INFORMATION CONSIDERED NECESSARY REGARDING EXPLORATORY SHAFT CONSTRUCTION AND SEALING

11/22/83 Response to NRC letter of June 15, 1983 on the subject of Exploratory Shaft Construction and Sealing.

**RESPONSE TO NRC LETTER OF JUNE 15, 1983 ON THE SUBJECT OF
EXPLORATORY SHAFT CONSTRUCTION AND SEALING**

Figure 1. Schematic Diagram of Shaft Operational Seals Showing Chemical Seal Ring (CSR)

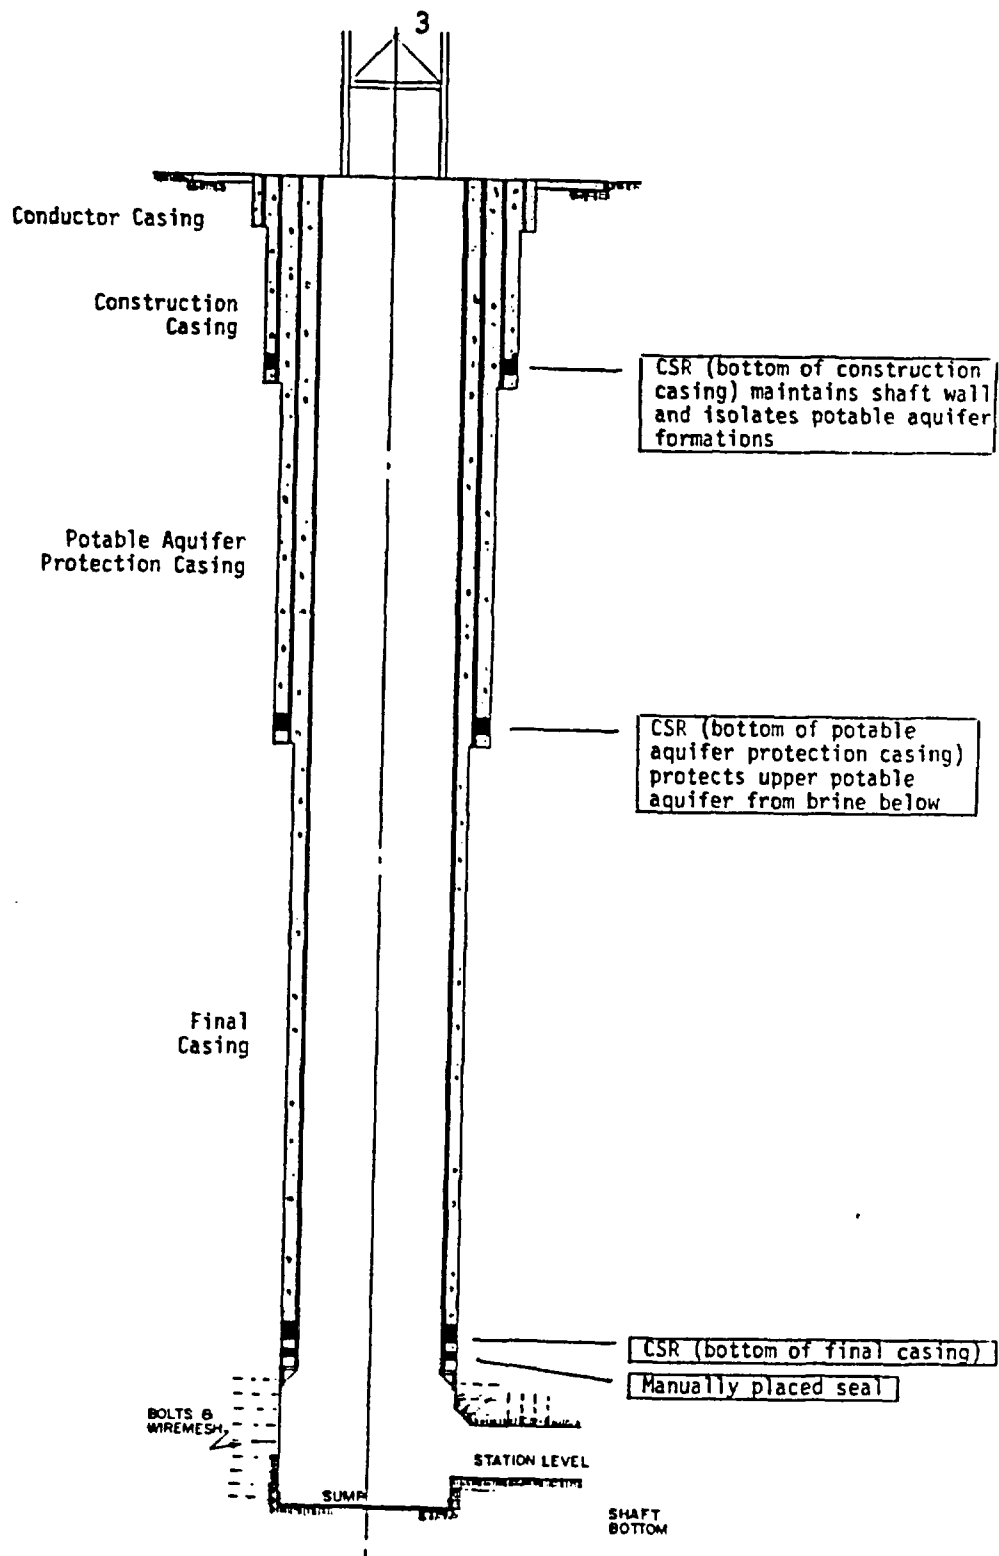
- C. Provide design specifications for the shaft construction and show how they deal with factors affecting sealing.**

The ES design specifications dealing with factors affecting sealing concern the short-term operational seals. For example, the design for the Permian Basin shaft calls for remotely placed chemical seal rings and oil field type grout seals, and a final manually placed operational seal. Figure 1 shows the location of the oil-field type grout seals and chemical seal rings (Reference 1). The details for the manually placed seal are shown in Figure 2 (Reference 1).

Multiple liners have been designed for various proposed sites. In the Permian Basin, for example, four sets of liner casing (Figure 1) are required to support the shaft walls and prevent ground water migration (References 1, 2).

Figure 3. Schematic Diagram of Shaft Decommissioning Seals

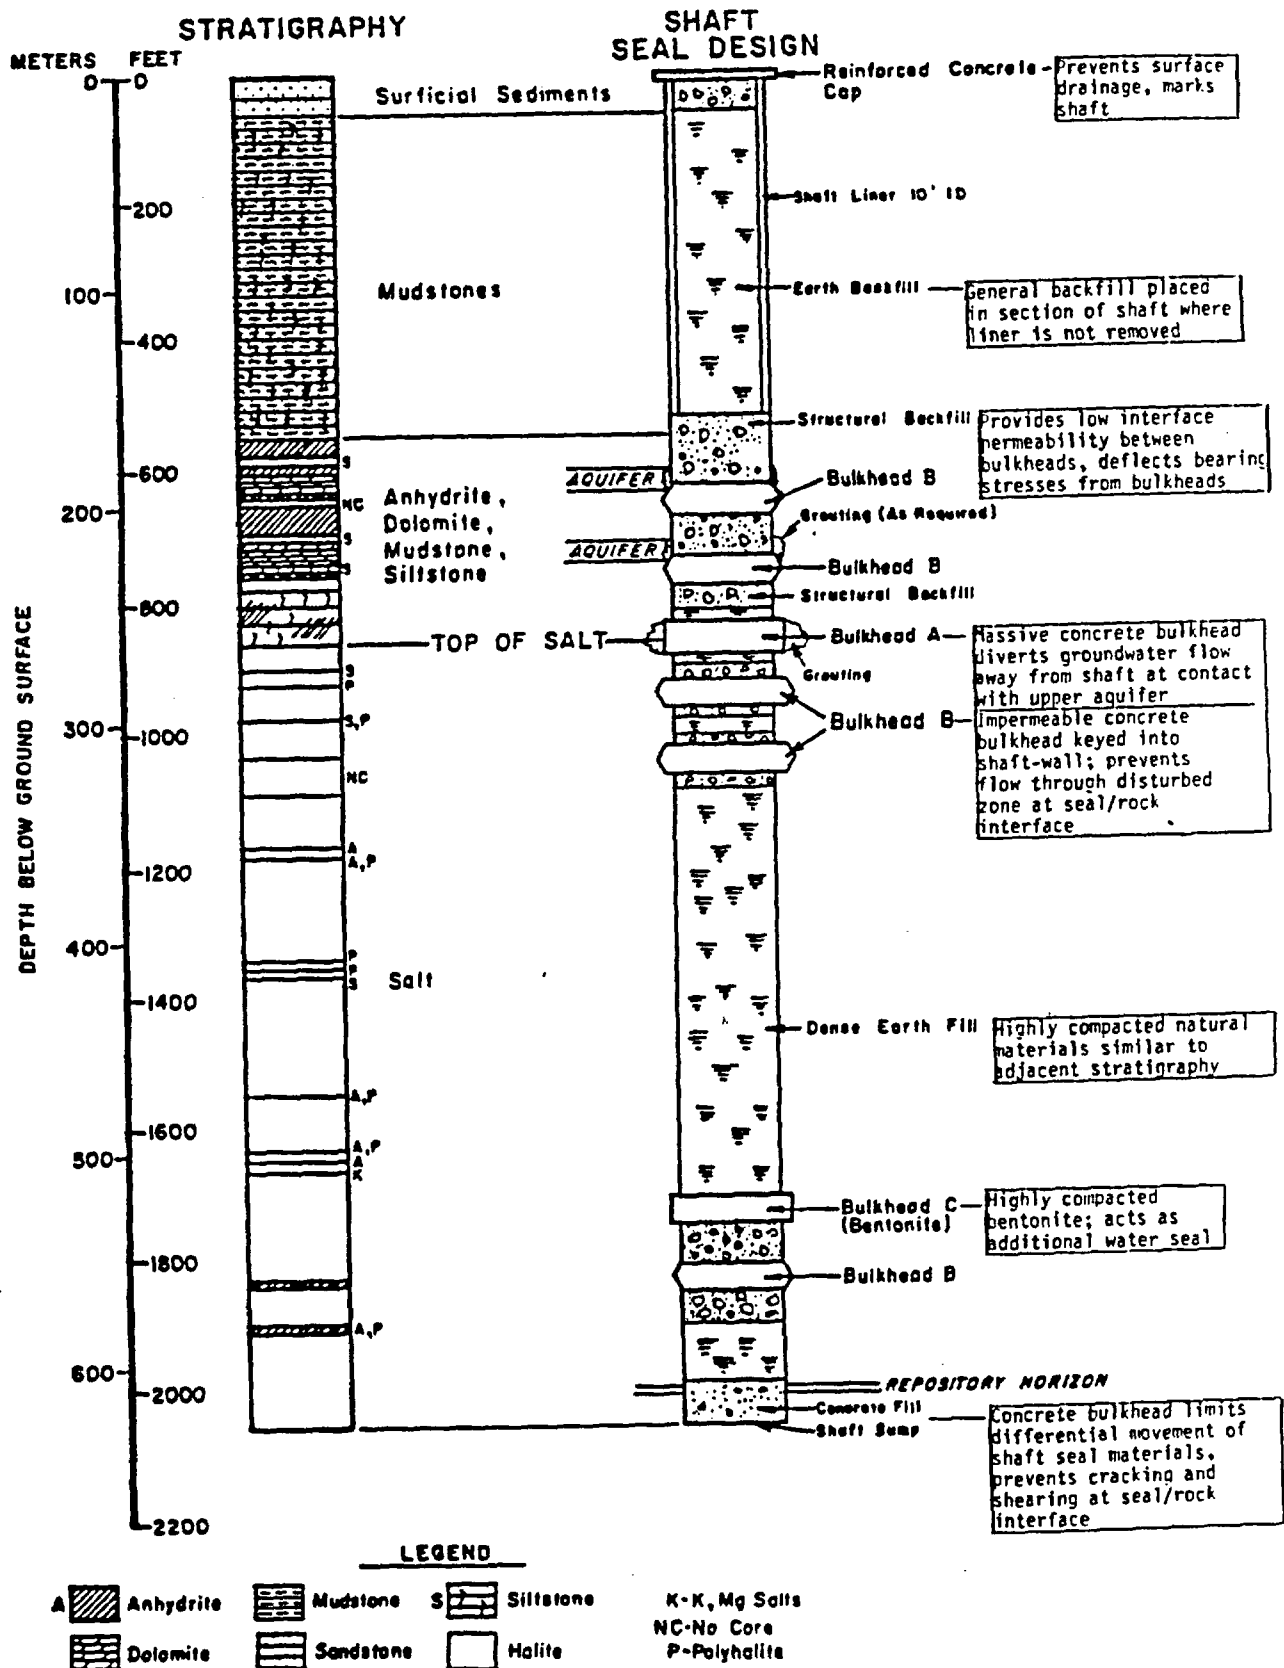
D. Describe the seal design and materials.

The long term decommissioning shaft seals include multiple components (References 7, 10). As shown in Figures 3 and 4, there are: three types of "bulkhead seals"; three types of backfill material between the bulkhead seals; and top and bottom structures. The bulkheads constructed of concrete will use mix designs based on PSU and WES formulations developed for borehole sealing (Reference 11). Aggregates used in the concrete will be compatible with the adjacent stratigraphy.
